## CONSTRUCTION CERTIFICATE APPLICATION ACCESSIBILITY DESIGN COMPLIANCE STATEMENT

**Project Name**                      Bakaa Cultural Centre

**Project Address**                44 Reid Street, Wilcannia, NSW 2836

**Date:**                                22nd May 2023

Ground Level Plan extract

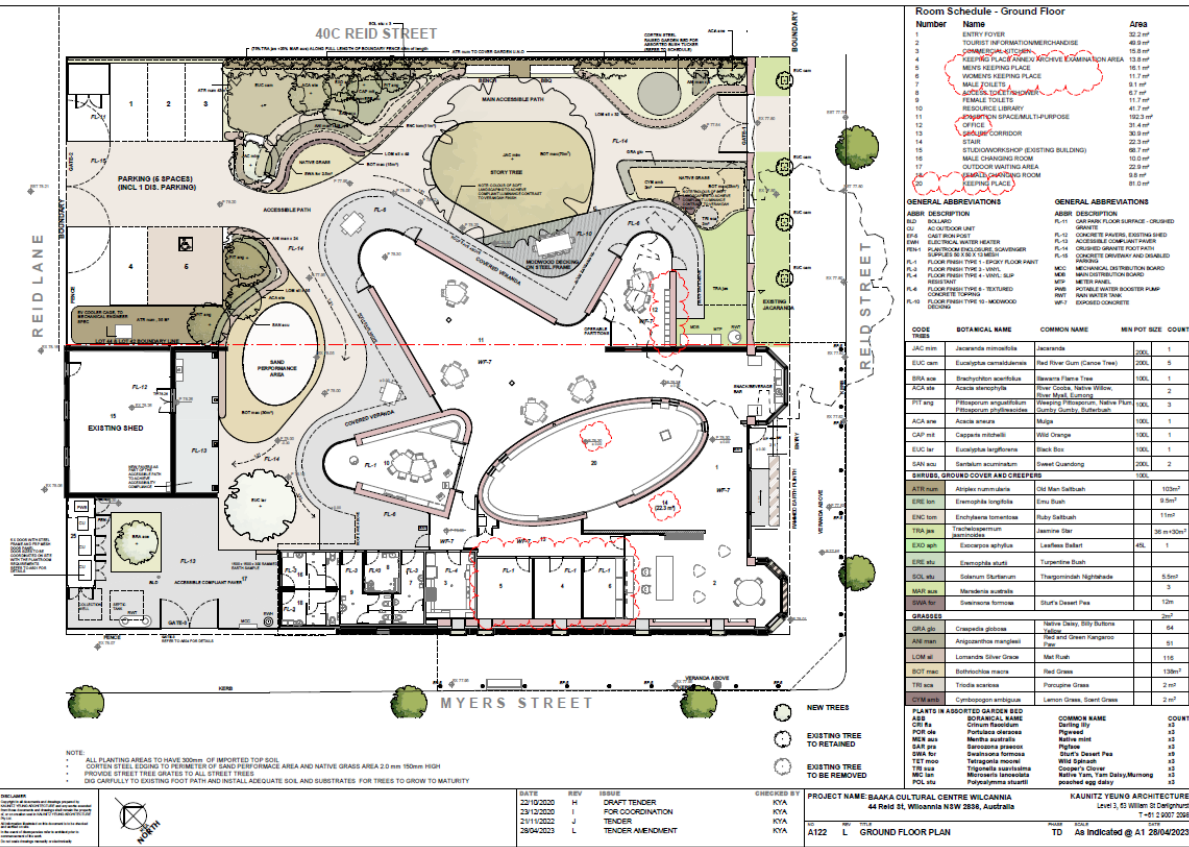
1. Accessible path to covered verandah & Sand Performance area access
  - Portable 1:10 ramp to be stored on site 3.5 m length. Staff to assist someone in a wheelchair.
